Revision A

A HERITAGE IMPACT STATEMENT FOR KEYSFORD BARN,
TREEMANS ROAD, HORSTED KEYNES, RH17 7EA.

Archaeology Services Lewes

Project number: ASL 354-25

Fig. 5. Proposed west elevation drawing ©Gould Baxter drawing number GH841-PL.10 updated 1/5/25.

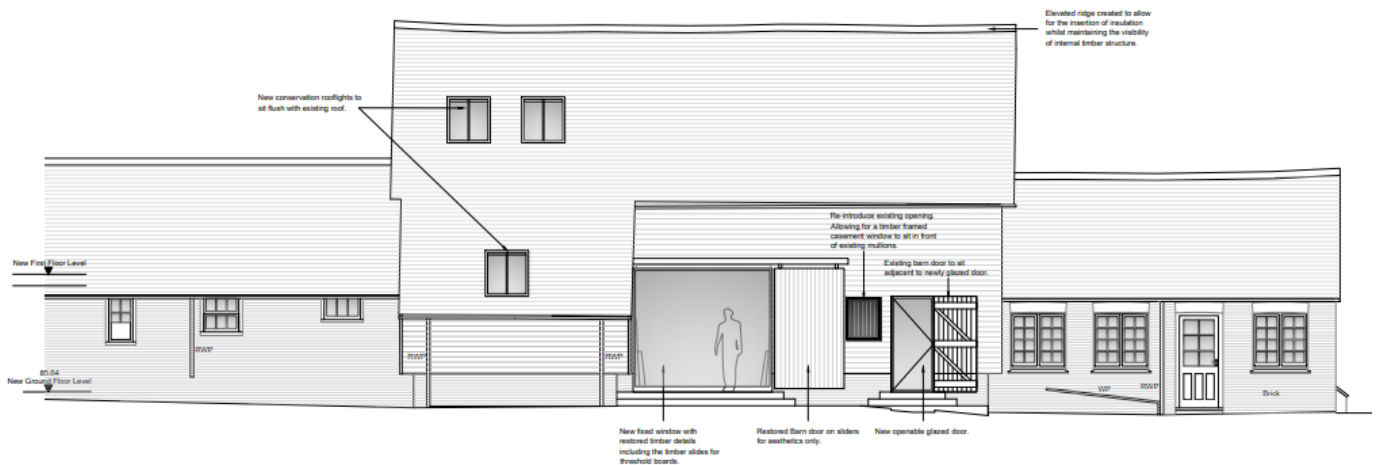
- The Midstrey door to the rear will be fitted with a fixed glass panel (Fig. 5). The doors (non-historic) will be repaired and fixed onto a sliding rail. There are no concerns regarding this proposal as these will be removable and will not hugely impact historic fabric and by introducing light in this elevation, will preserve the Principal elevation thereby retaining the setting of the important side of the building, so is supported. A sliding rail will ensure the doors can still be retained, although they are modern in date and not historic.

- A fixed glazed panel is proposed above the Wagon way on the west side. This panel is a more modern introduction, likely built when the doors were replaced so the proposals will not impact historic fabric.

Fig. 6. Proposed first floor plan ©Gould Baxter drawing number GH841-PL.10 updated 1/5/25.

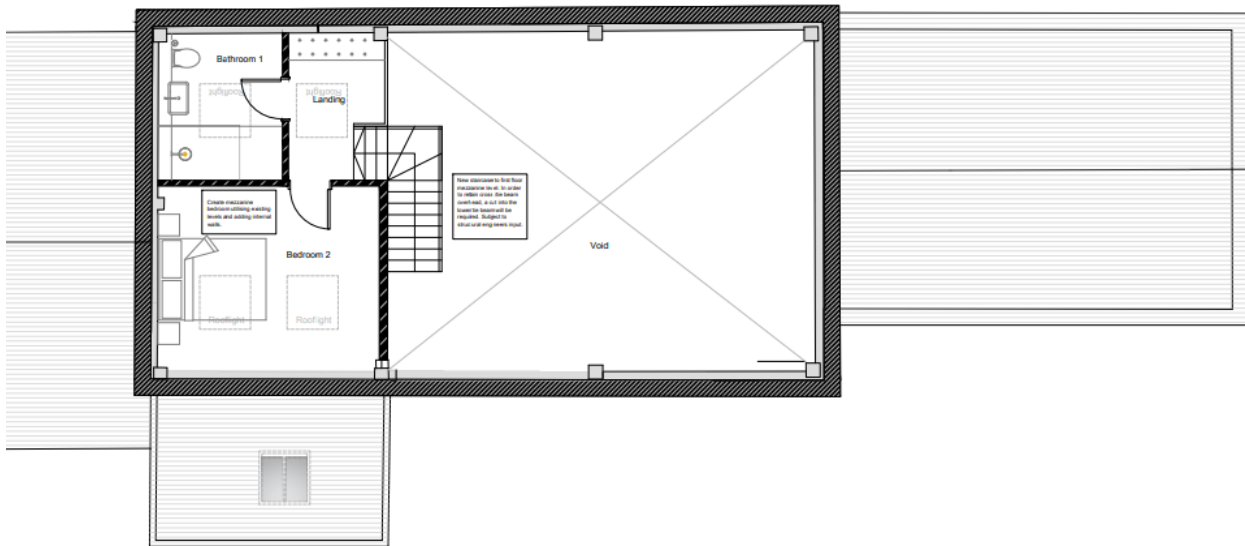
- A staircase will be built to access the mezzanine floor from the central bay (Fig. 6). This would require a small truncation of the existing mid-tiebeam in this location in order provide access for the stairs. This mid-tiebeam is part of a 20th century addition to the bay so is not considered historic or significant and so is supported. The partition wall below the mid-tiebeam is also modern, as is the whole of the floor in this bay so any impacts to this fabric are of little concern. However, fixing to the threshing boards at the base will need to be minimal and preferably avoid any cutting of the fabric here.

Fig. 8. Proposed south elevation drawing ©Gould Baxter drawing number GH841-PL.10 updated 1/5/25.

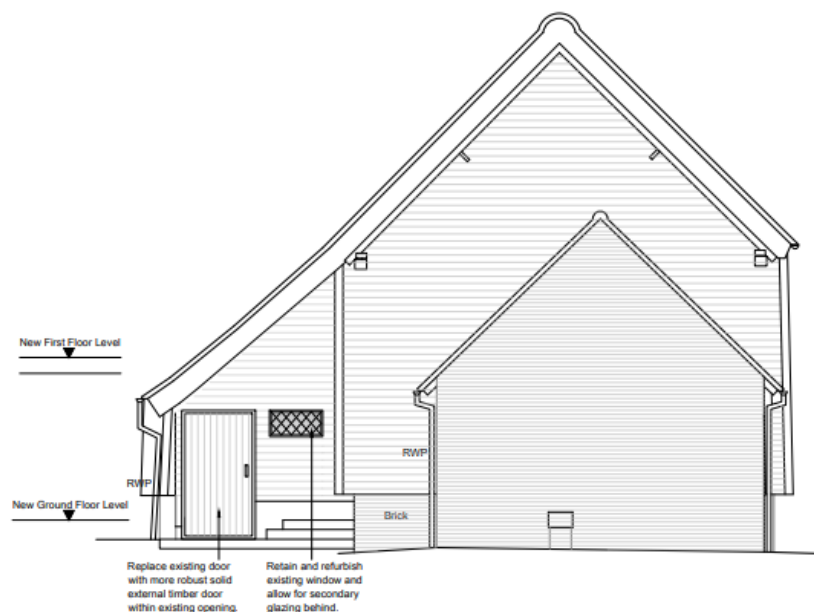
- The existing doorway to the south will be replaced by a new doorway and door (Fig. 8). The door does need upgrading but it may be possible to repair the existing door but this would need to be confirmed by a carpenter. The door is not original to either Period A or B *in its present location* but it is of historic significance (it may have originally belonged to the house). It might be appropriate to perhaps fix the door elsewhere internally, if considered appropriate by the CO.
